**Skilled Nursing Care / Mental Health Unit /
HIV – AIDS Unit and Renovation of Related
Support Facilities for
ELAYN HUNT CORRECTIONAL CENTER
LA State Project No. 08-413-97B-1, Part 7**

Addendum No. Three

ADDENDUM INFORMATION CIVIL
ELAYN HUNT SKILLED NURSING FACILITY
State Project No. 08-413-97B-1, Part 7
F&T Job No. 84637

PROJECT NO. 04021 / 520424 SHEET NO. **A2.14**

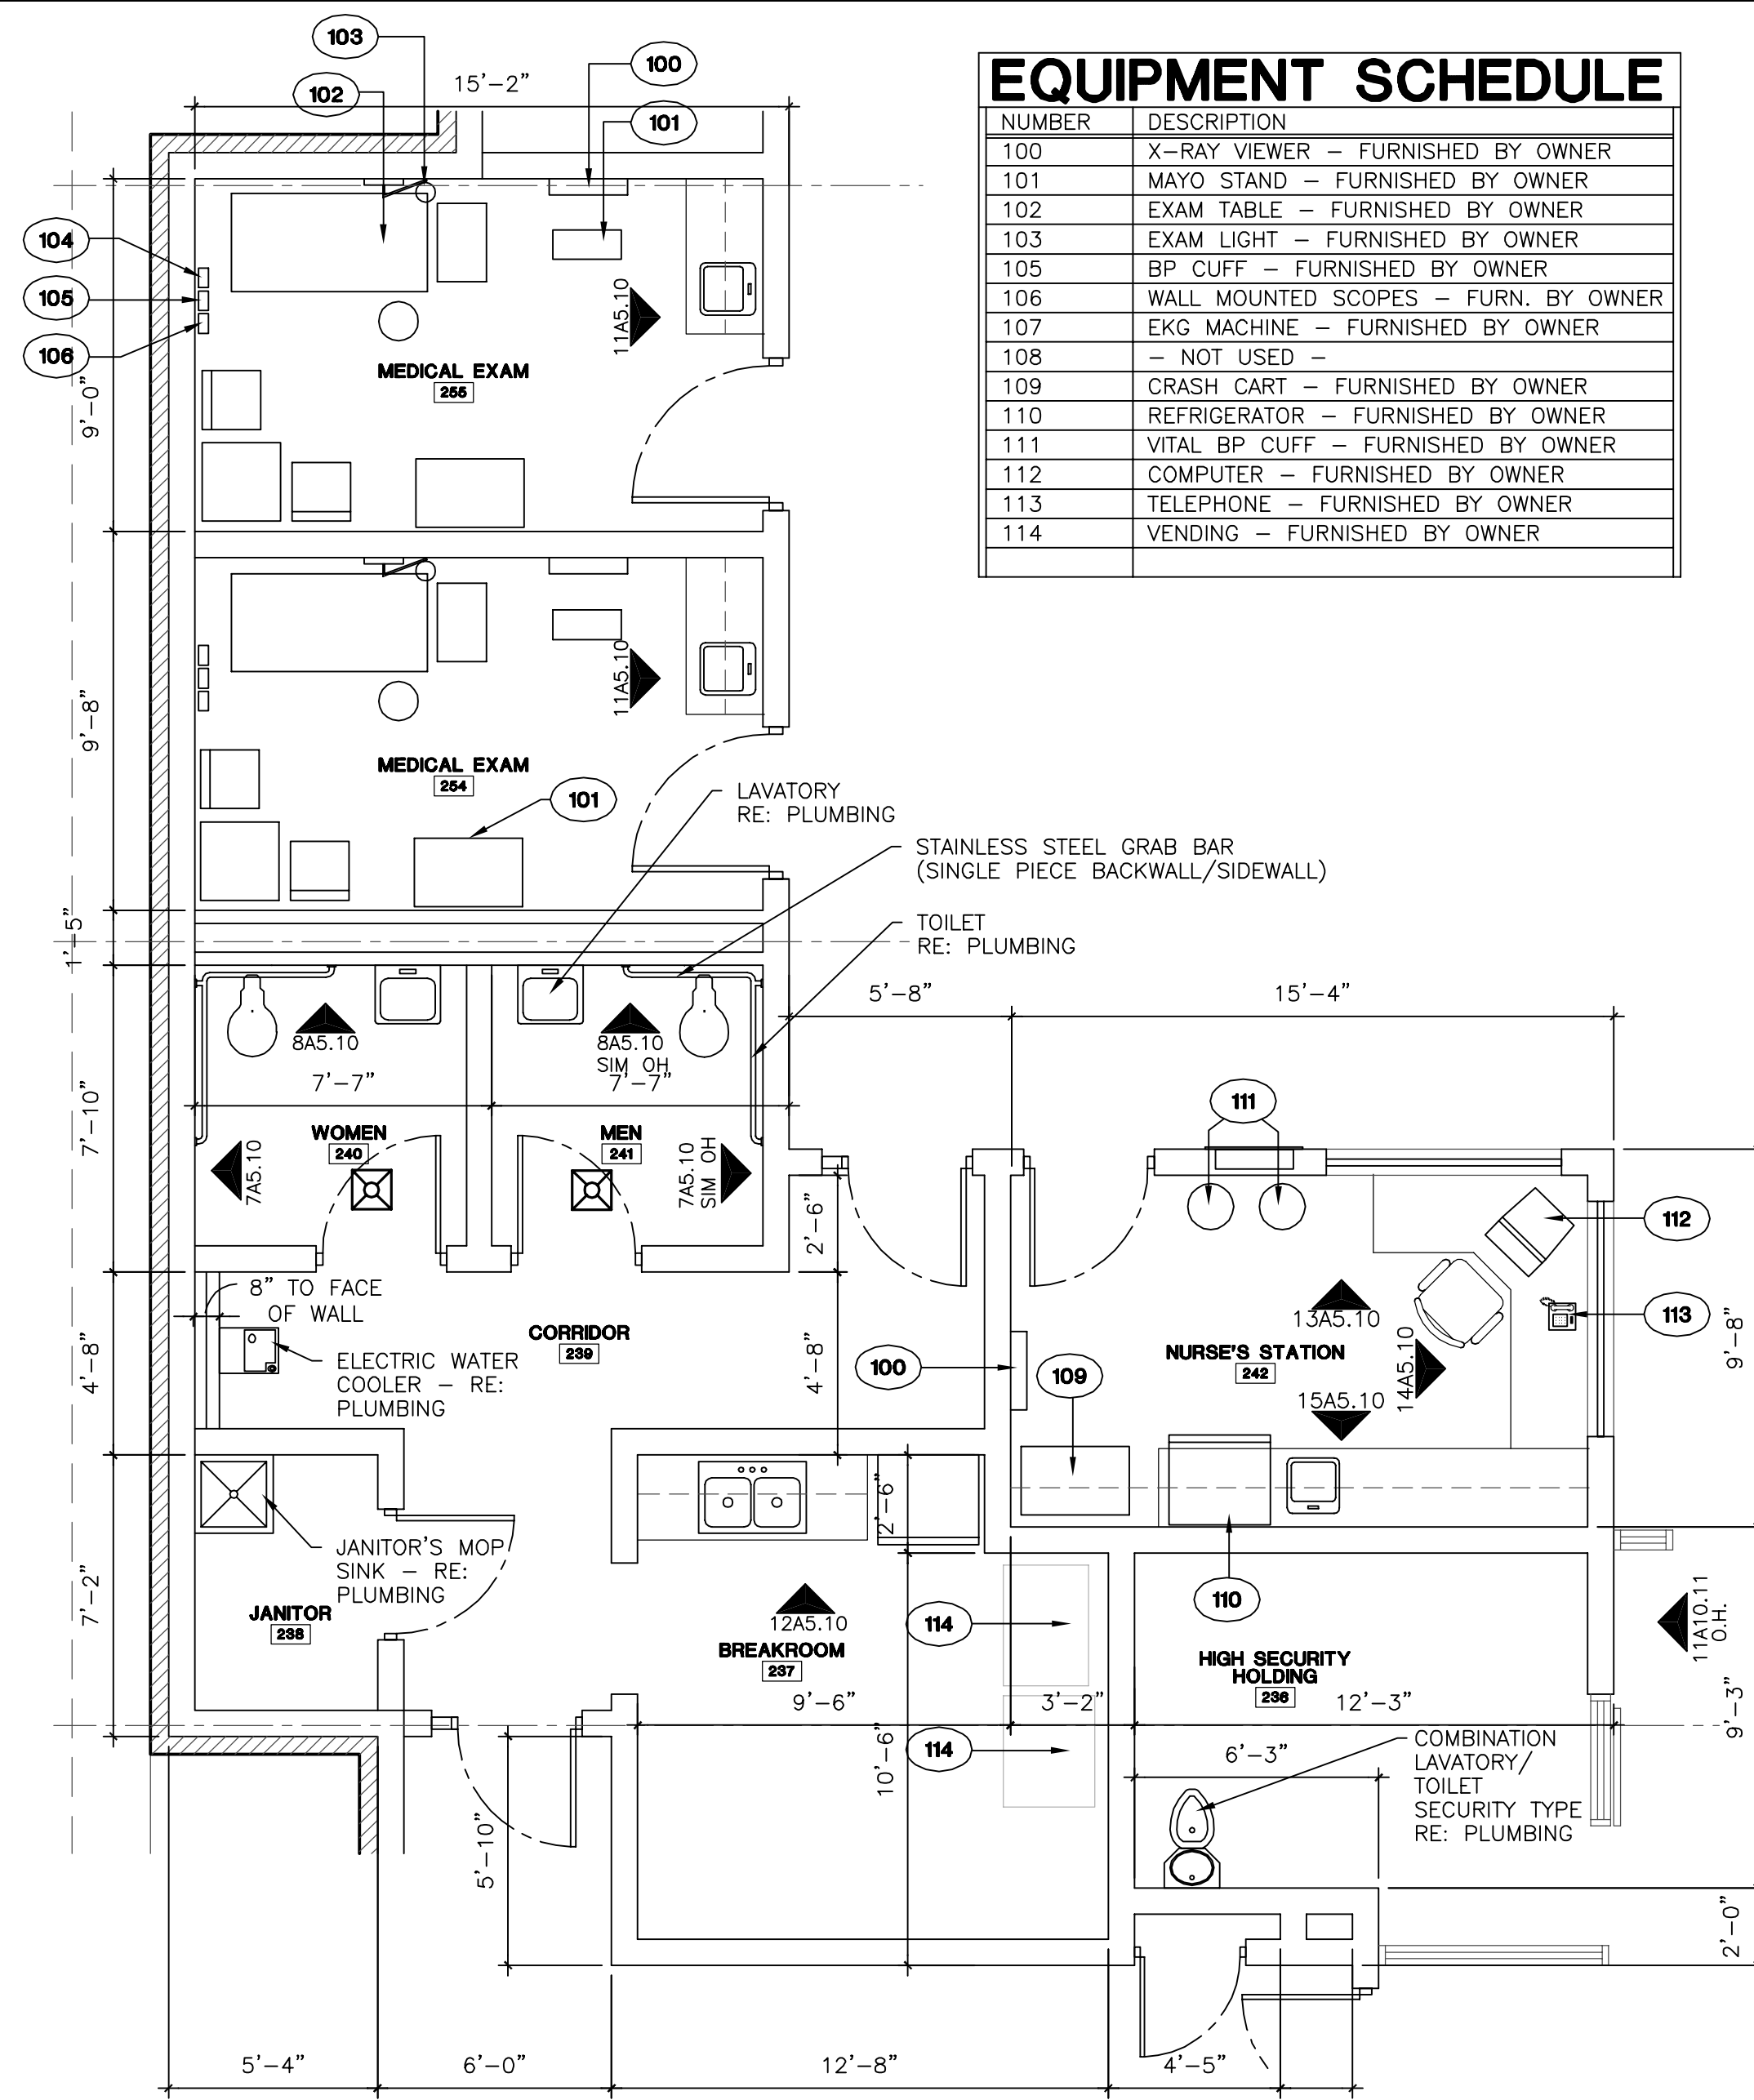
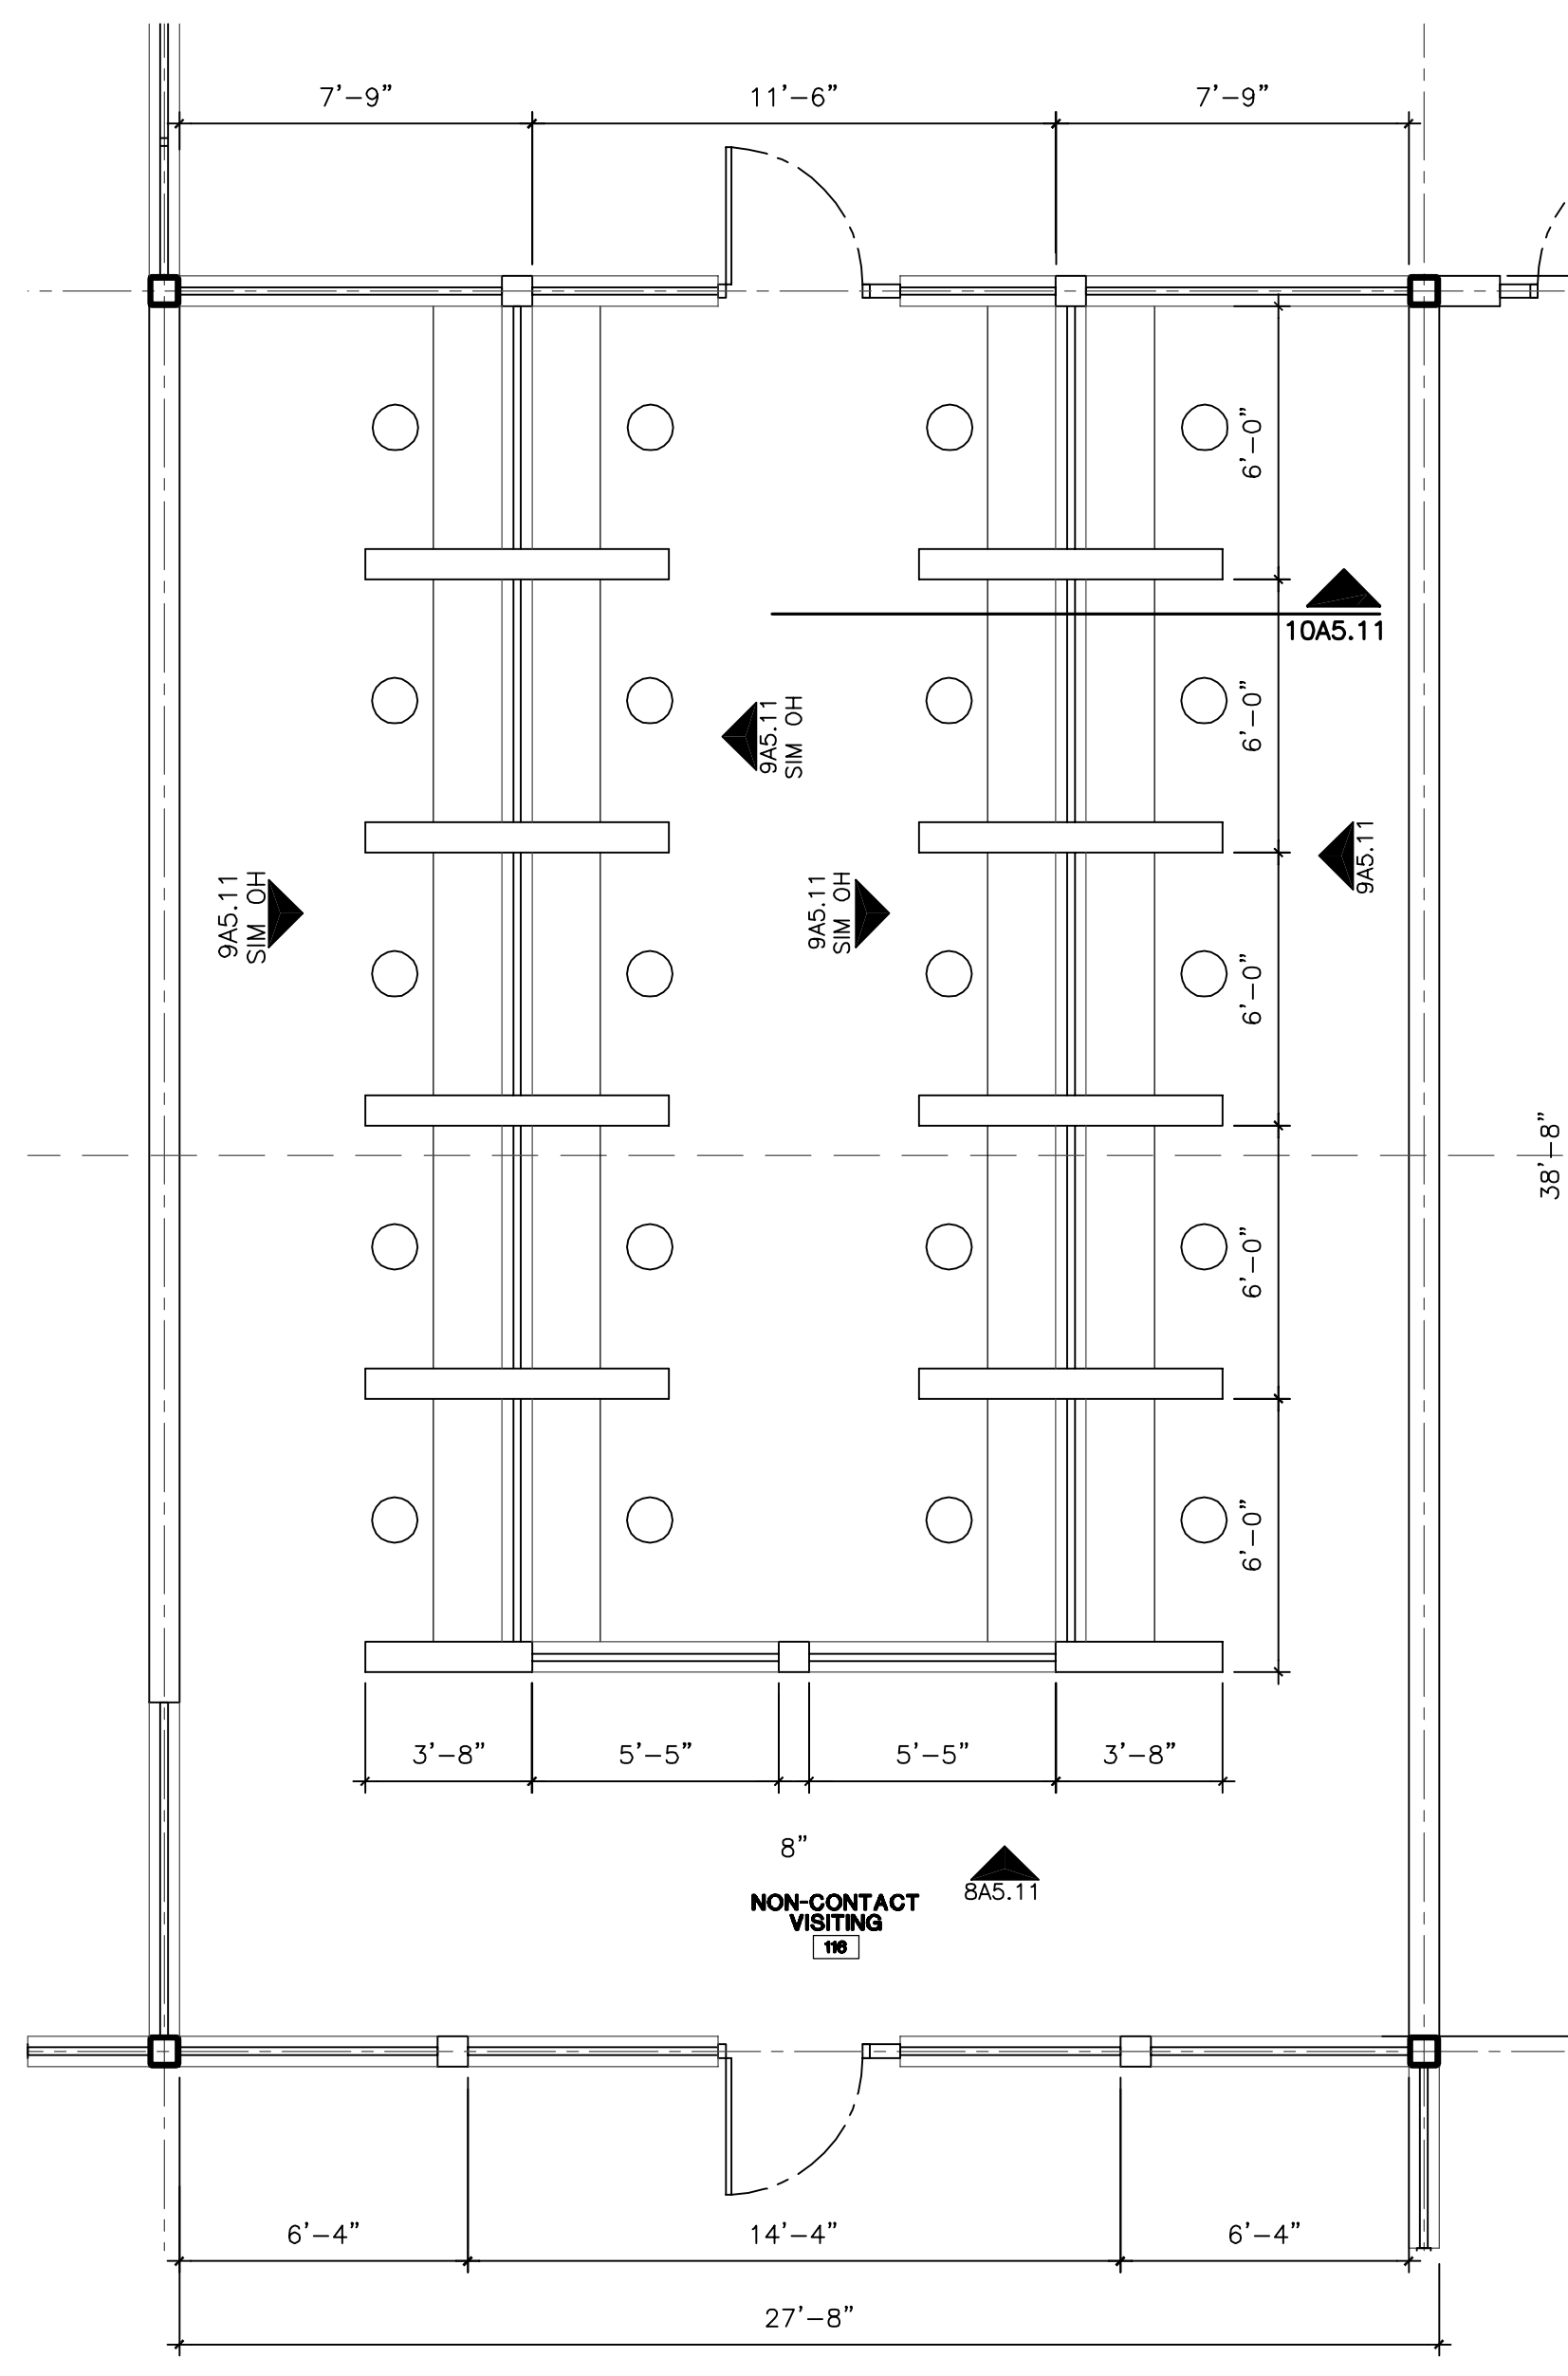
- 9) Please see attached revised A2.14 for clarification of transaction counters.

- 10) The wall height for the 4'-8" walls separating the transaction counters shall be to the underside of the metal deck.
- 11) Specification Section 07620 calls for pre-painted aluminum. This should be revised to state pre-painted steel.
